## Alert Service Bulletin No. 074

## **Turbocharger Center Housing Inspection**

Turbocharger Data Tag Locations  
Figures 1 & 2

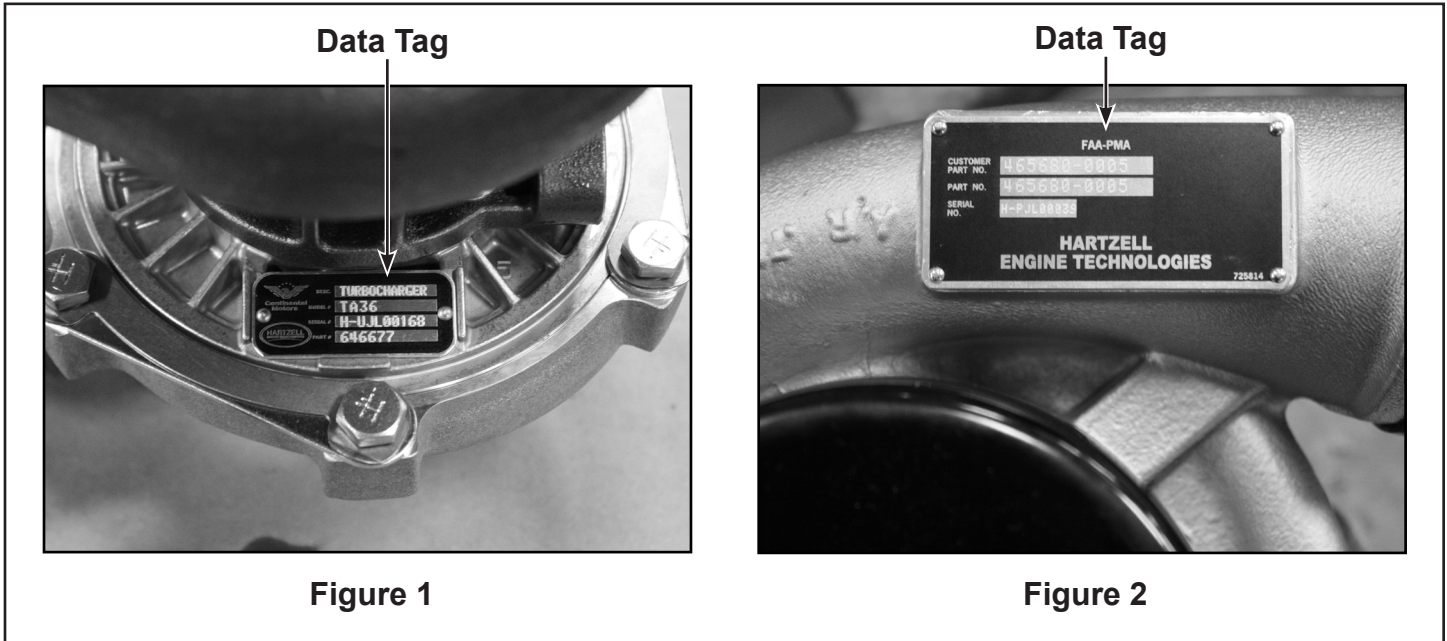
**NOTE :** The turbocharger data tag can be found in one of two locations depending on model. Refer to Figures 1 & 2 for locations.

Turbocharger Center Housing Oil Drain (lower) Flange  
Figures 3 & 4

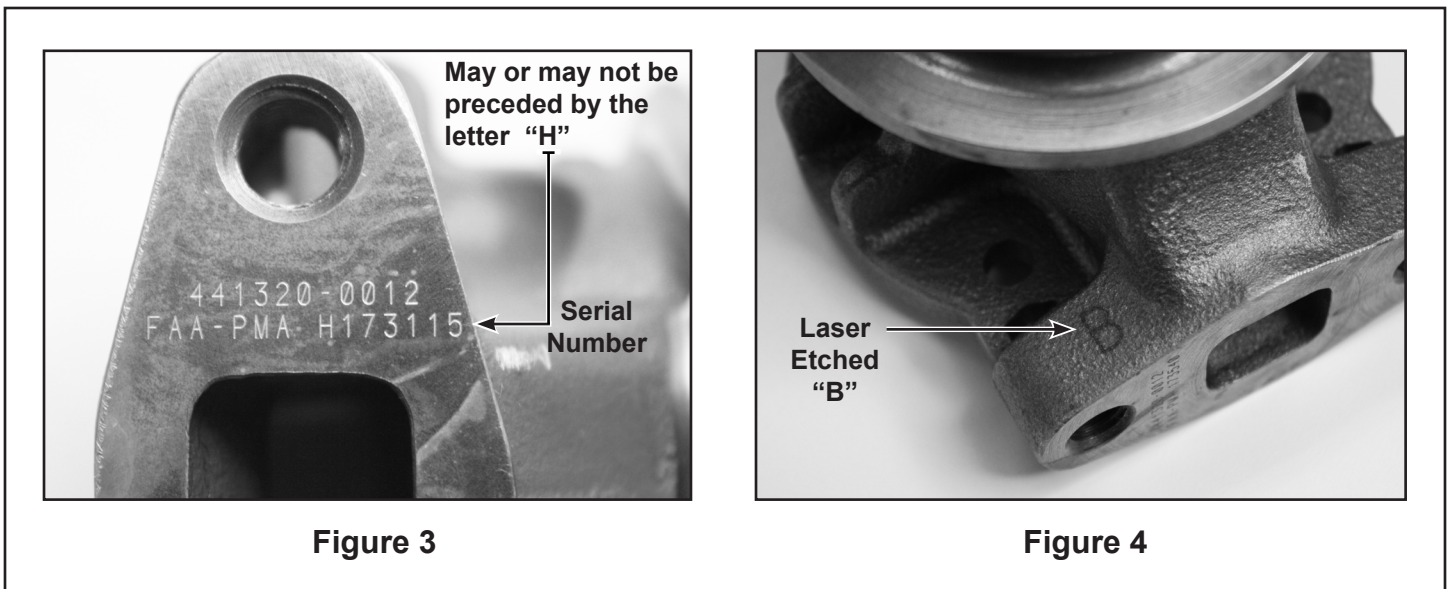
- (3) If the turbocharger was serviced between 10 May, 2017 and the effective date of this ASB, and effectivity cannot be established from the maintenance records, utilize the applicable aircraft maintenance manual to gain access to and remove the turbocharger center housing oil drain line from (lower) flange. Inspect turbocharger center housing serial number against affected serial numbers found in Table 2 of this ASB. (See Figure 3 for serial number illustration)

**NOTE:** Serial numbers found in Table 2 may or may not be preceded by the letter “H” as shown in Figure 3.

- (1) Affected turbochargers and/or center housings
  - (a) Replace turbocharger center housing with one not associated with this ASB.
    - 1 Replacement center housing may be new or factory reworked.
    - 2 Factory reworked center housings will be identified by a laser etched “B” located on the side of the oil drain flange (See Figure 4).
